MIL-C-28840A  
 AMENDMENT 6  
 5 May 2000

## MILITARY SPECIFICATION

CONNECTORS, ELECTRICAL, CIRCULAR THREADED, HIGH DENSITY,  
 HIGH SHOCK SHIPBOARD, CLASS D, GENERAL SPECIFICATION FOR

This amendment forms a part of MIL-C-28840A, dated 26 May 1981, and is approved for use by the Space and Naval Warfare Systems Command, Department of The Navy, and is available for use by all Departments and Agencies of the Department of Defense.

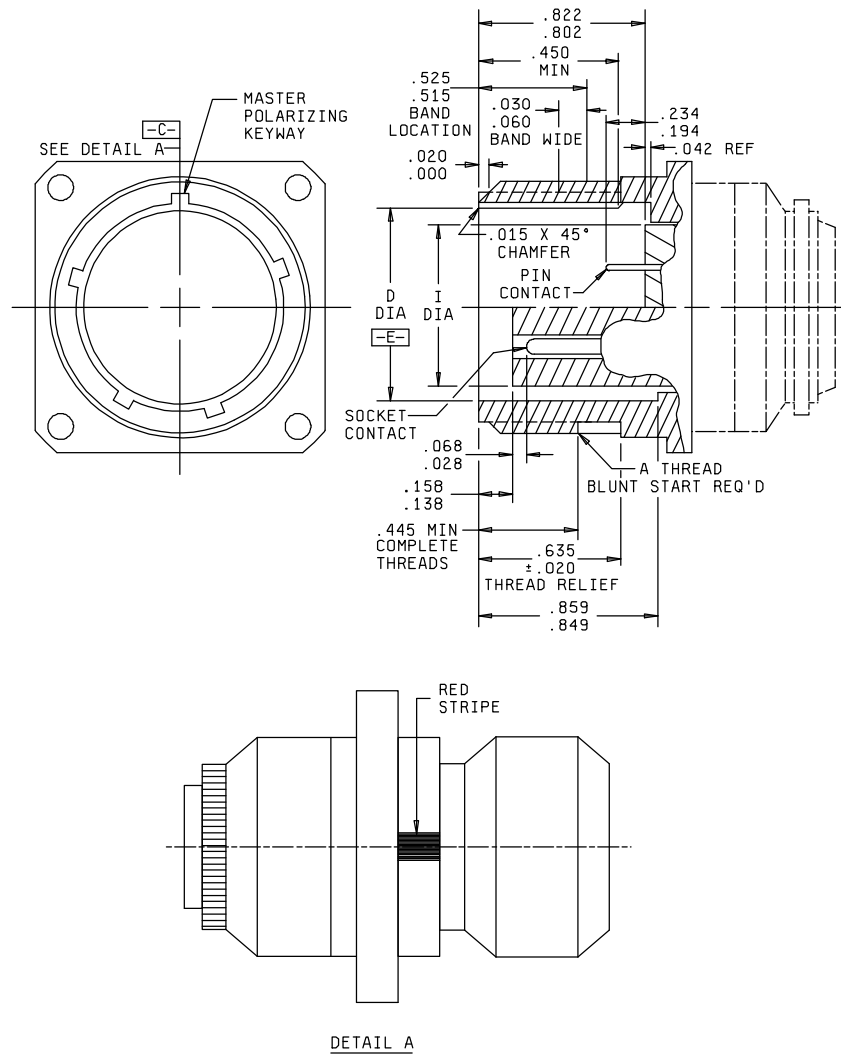
FIGURE 4, add to vertical centerline the datum feature symbol “

-B-
-----

FIGURE 10. External bending moment test set -up.”

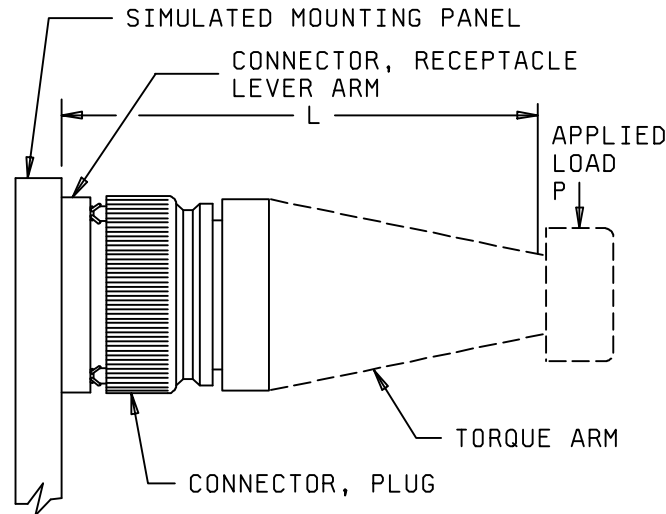
4.6.17, delete and substitute:

“4.6.17 External bending moment (see 3.21). The receptacle connector shall be mounted as in normal service to a rigid panel. Before mating the plug connector to the receptacle, and adapter or test torque arm shall be attached as shown on figure 10. After mating the plug and receptacle connectors, the distance “L” from the point of load application “P” to the mounting panel shall be determined. The load shall be applied at point “P” and shall then be determined as the bending moment listed in table XII, divided by the level arm “L”. This load shall be applied at a rate of approximately 10 pounds per second until the required load is achieved. The applied load shall be held for 1 minute, then the load shall be released.

FIGURE 10, delete and substitute:
